February 27, 2014
RC-14-0030

Subject: VIRGIL C. SUMMER NUCLEAR STATION (VCSNS) UNIT 1
DOCKET NO. 50-395
OPERATING LICENSE NO. NPF-12
SOUTH CAROLINA ELECTRIC & GAS COMPANY'S SECOND SIX-MONTH
STATUS REPORT IN RESPONSE TO MARCH 12, 2012 COMMISSION ORDER
MODIFYING LICENSES WITH REGARD TO REQUIREMENTS FOR
MITIGATION STRATEGIES FOR BEYOND-DESIGN-BASIS EXTERNAL
EVENTS (ORDER NUMBER EA-12-049) (TAC NO. MF2338)

Attachment I SCE&G's Second Six Month Status Report for the Implementation of Order EA-12-049, Order Modifying Licenses with Regard to Requirements for Mitigation Strategies for Beyond-Design-Basis External Events

Attachment II Conceptual Sketches of Strategies

Figure 1 – Conceptual Phase 1&2 Coping for SG Feed Makeup

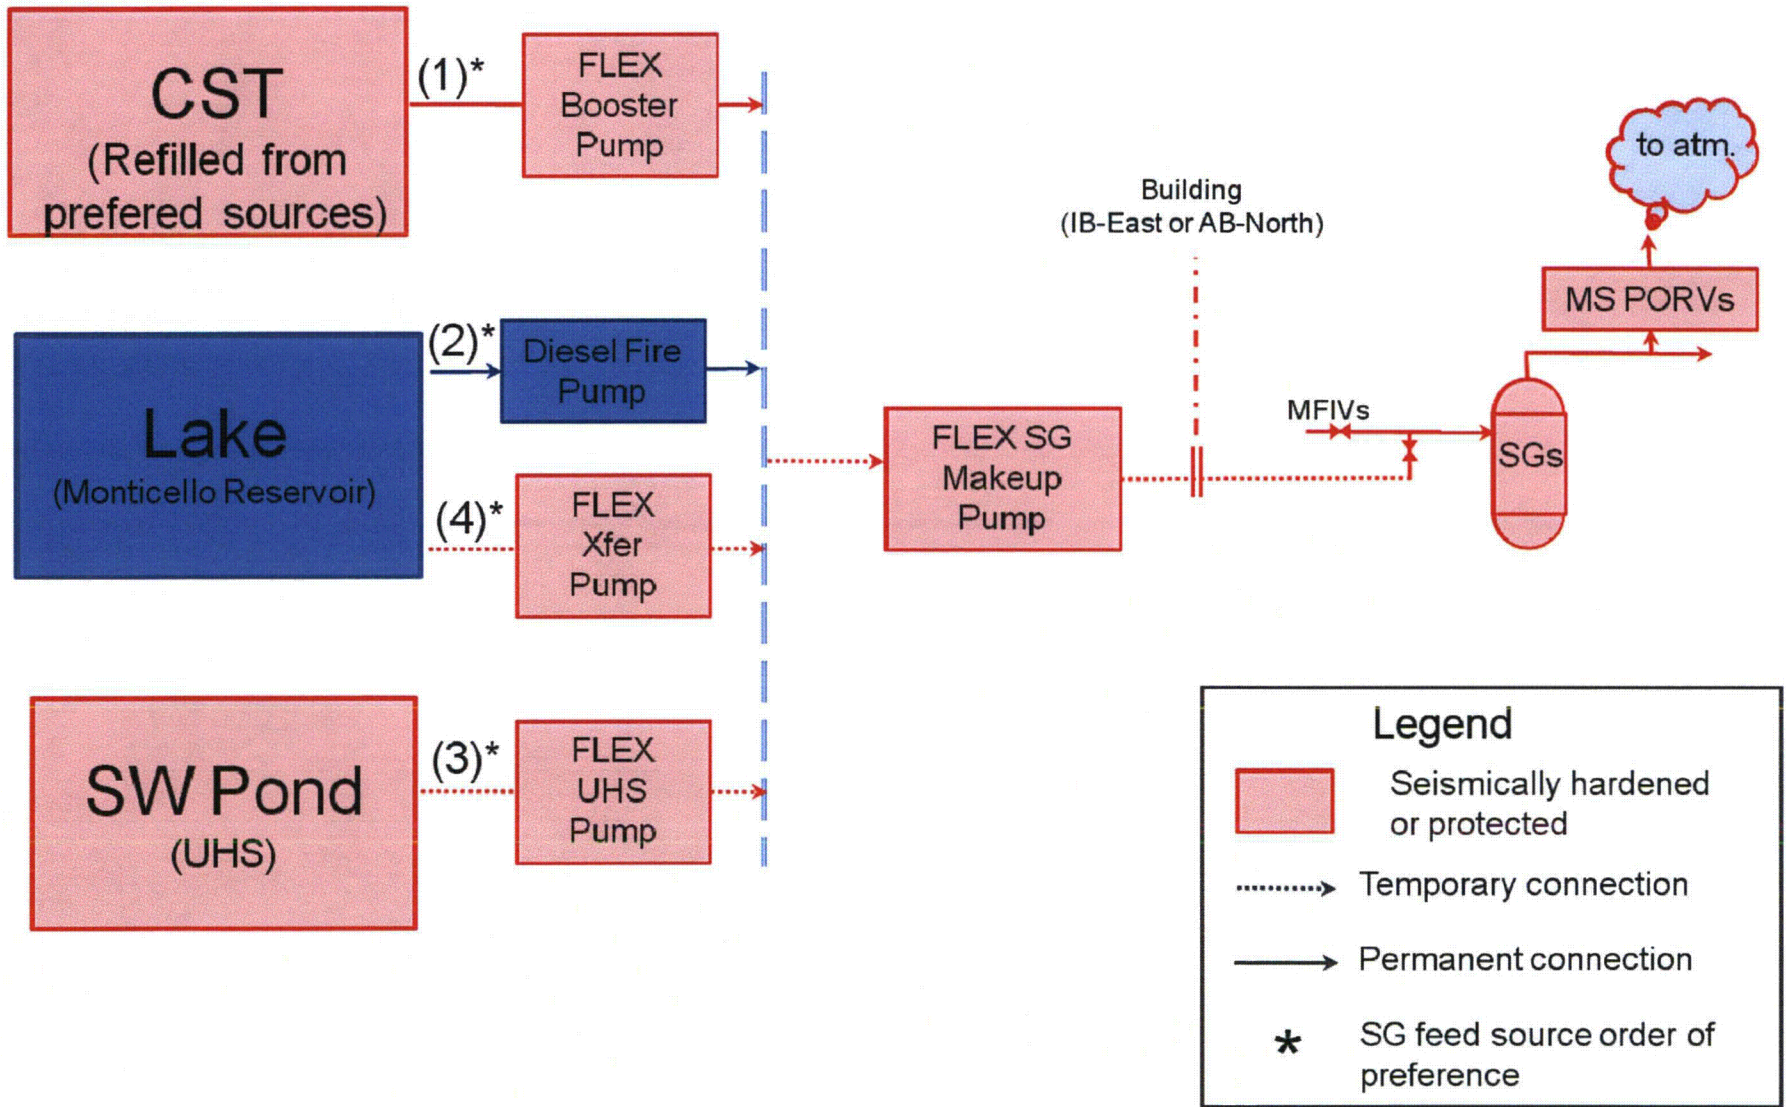
Figure 1 – Conceptual Phase 1&2 Coping for SG Feed Makeup was revised and reissued in Attachment II of this submittal. The significant changes to the figure are as follows: (1) added FLEX Booster Pump between CST and FLEX SG Makeup Pump and (2) replaced reference to FLEX Feed Header to Building connection (Intermediate Building-East or Auxiliary Building-North).

Figure 2 – Conceptual Diverse Strategy for Supplying FLEX SG makeup

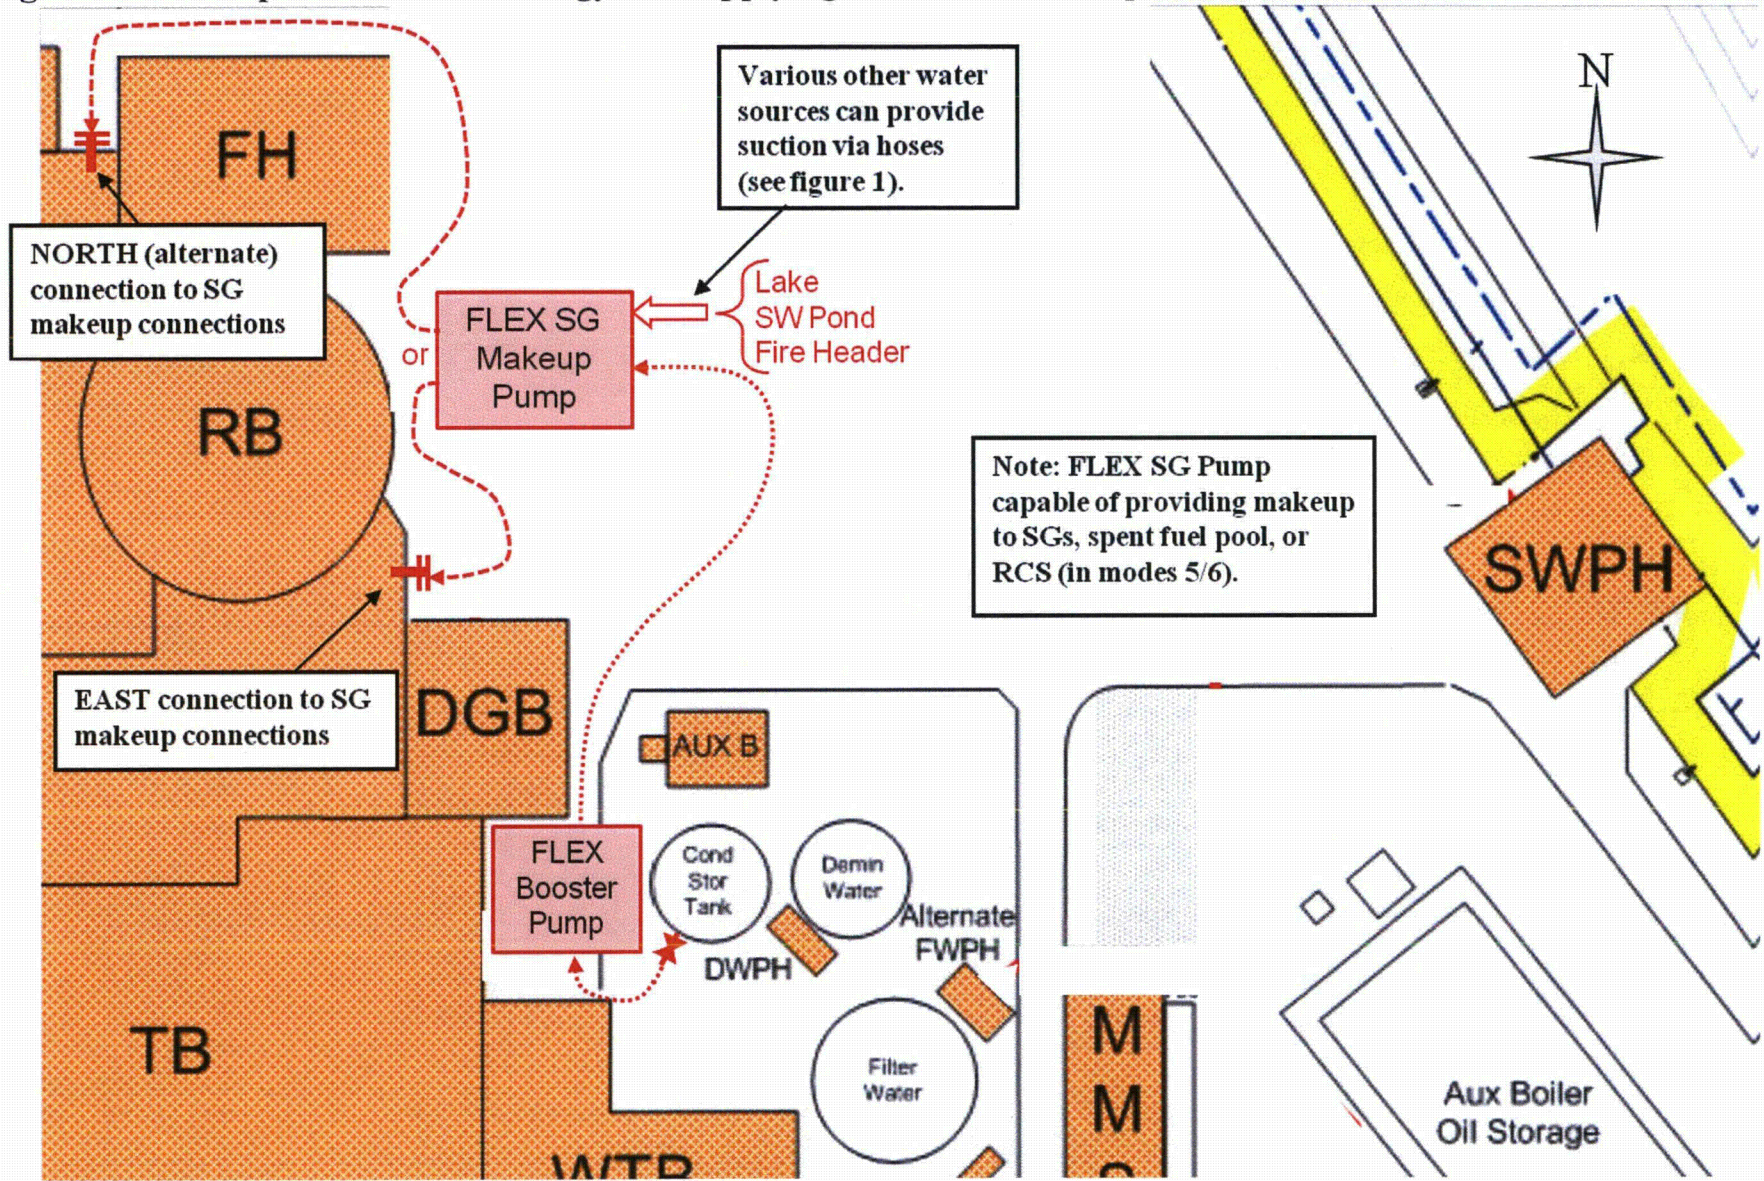
Figure 2 – Conceptual Diverse Strategy for Supplying FLEX SG Makeup was revised, renamed, and reissued in Attachment II of this submittal. The significant changes to the

figure are as follows: (1) revised the figure name to reflect the strategy for supplying the FLEX SG Makeup Pump, (2) revised location and name for FLEX Booster Pump, (3) changed Suction of East FLEX SG Makeup Pump to be from CST via FLEX Booster Pump instead of from EFW Supply Lines, and (4) made note that FLEX SG Pump can be used for RCS makeup in modes 5/6.

Figure 3 – Conceptual Phase 2 Coping for Refilling of CST

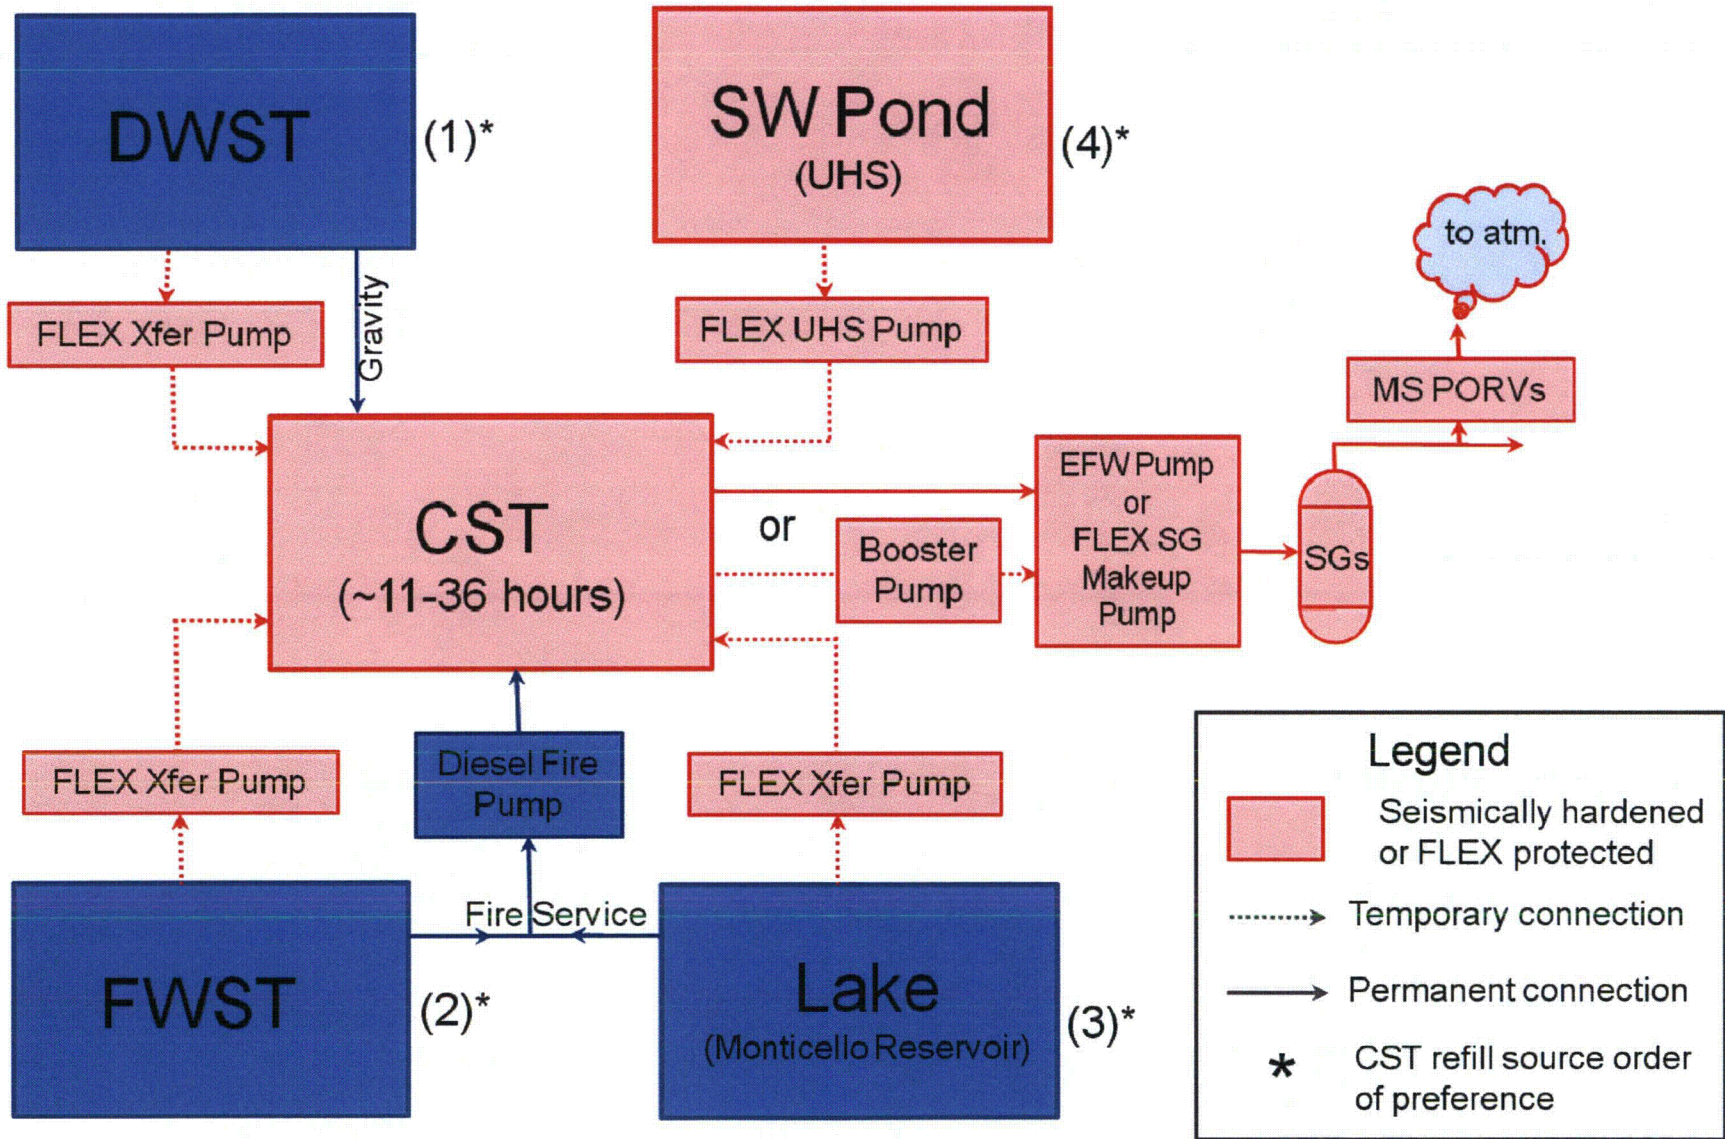
Figure 3 – Conceptual Phase 2 Coping for Refilling of CST was revised and reissued in Attachment II of this submittal. The significant changes to the figure are as follows: (1) changed pump to directly feed SG from TDEFW to EFW Pump to make generic and (2) added Booster Pump between CST and FLEX SG Makeup Pump.

Figure 4 – Conceptual Strategy for Reactor Makeup and Reactivity Control

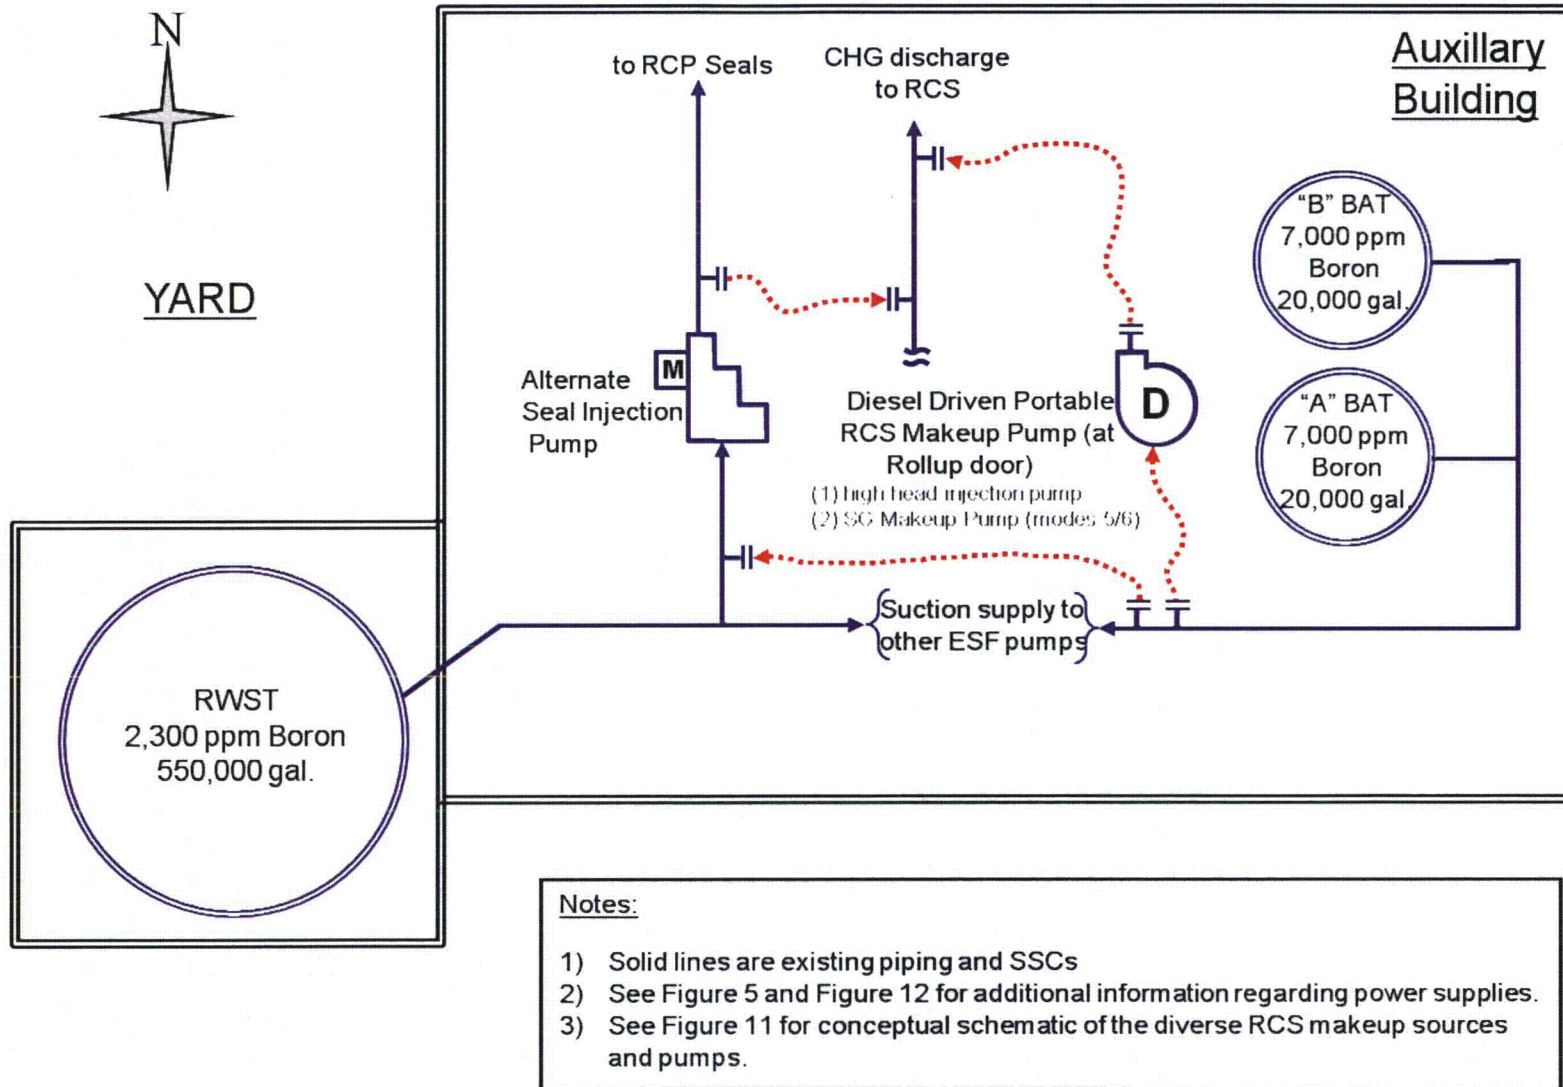
Figure 4 – Conceptual Strategy for Reactor Makeup and Reactivity Control was revised and reissued in Attachment II of this submittal. The significant changes to the figure are as follows: (1) changed the suction and discharge connections to be consistent with the revised RCS makeup strategy using a portable RCS makeup pump or FLEX SG Makeup Pump (mode 5/6) and (2) removed power sources for pumps and incorporated into notes.

Figure 5 – Conceptual Coping Strategies for Support Functions from EB

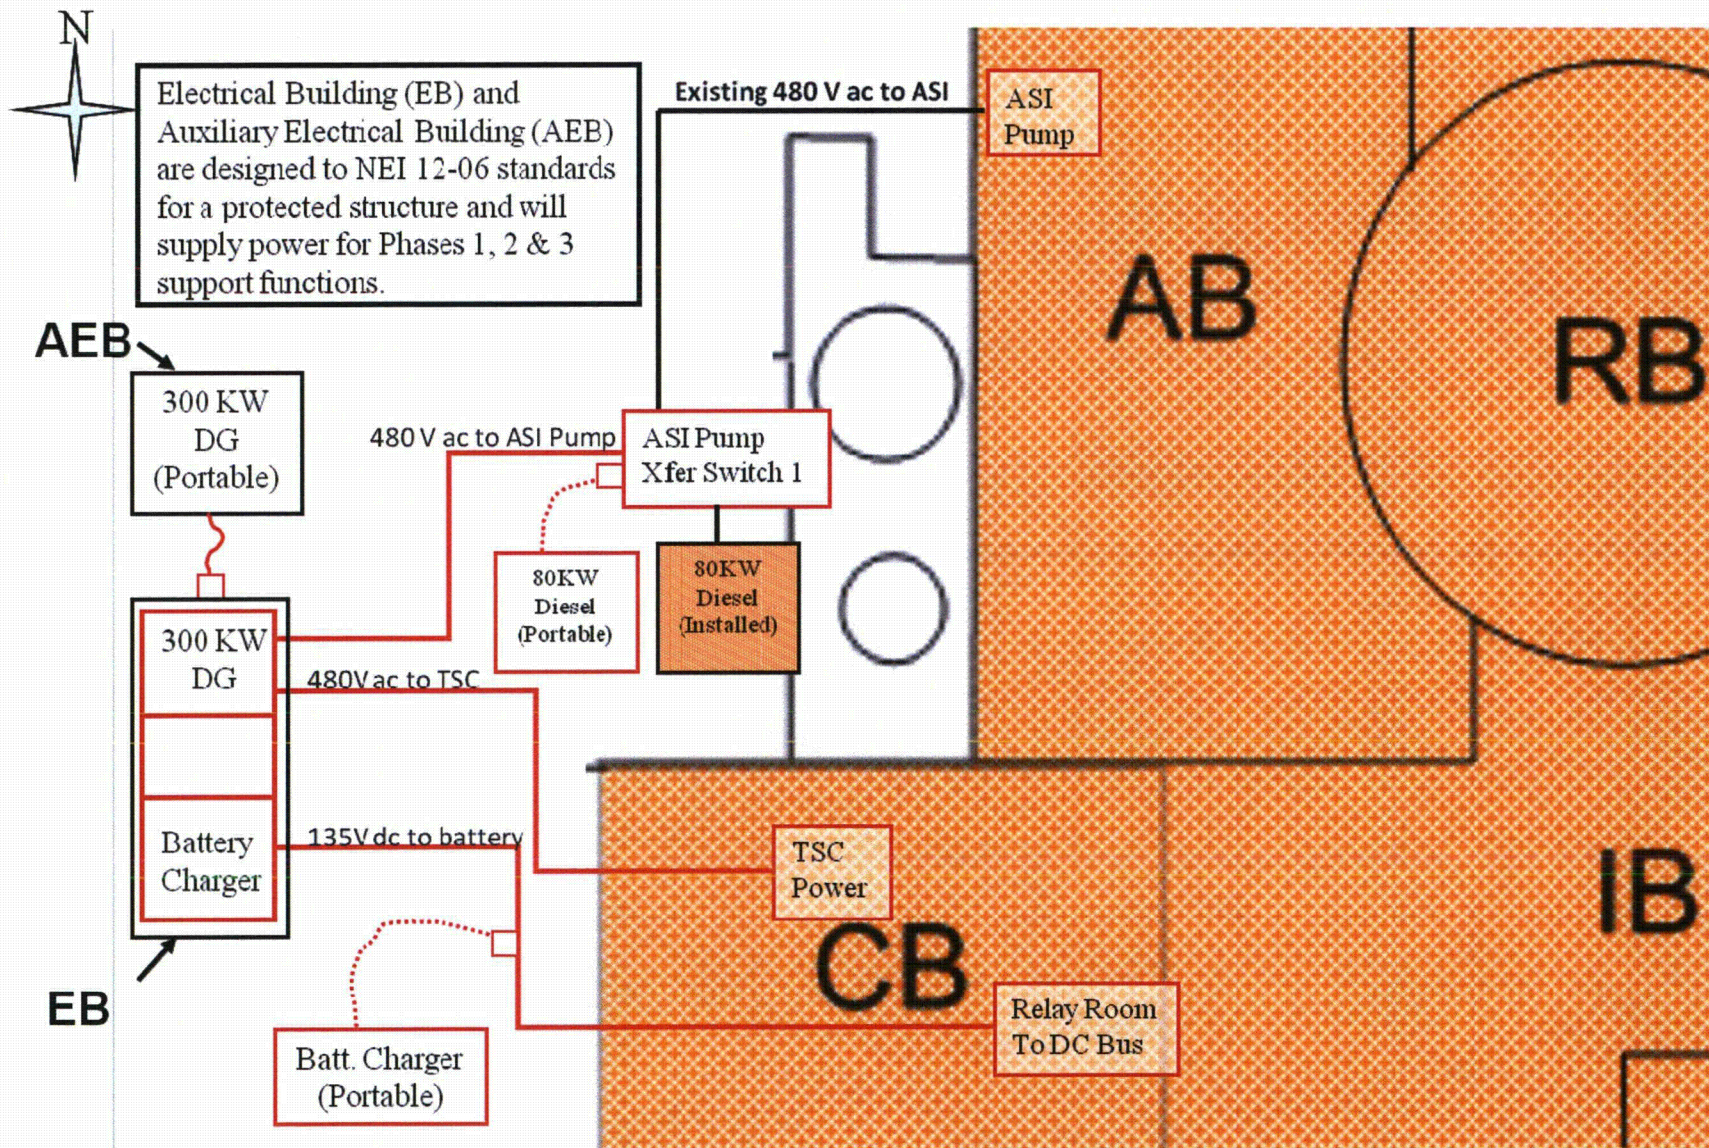
Figure 5 – Conceptual Coping Strategies for Support Functions from Electrical Building (EB) was revised, renamed, and reissued in Attachment II of this submittal. The significant changes to the figure are as follows: (1) revised name of EEB to reflect new name as EB, (2) added storage location of portable 300 kilowatt Diesel Generator in the Auxiliary Electrical Building (AEB), and (3) removed the previously envisioned series of transfer switches and RXMU FLEX Pump in the AB.
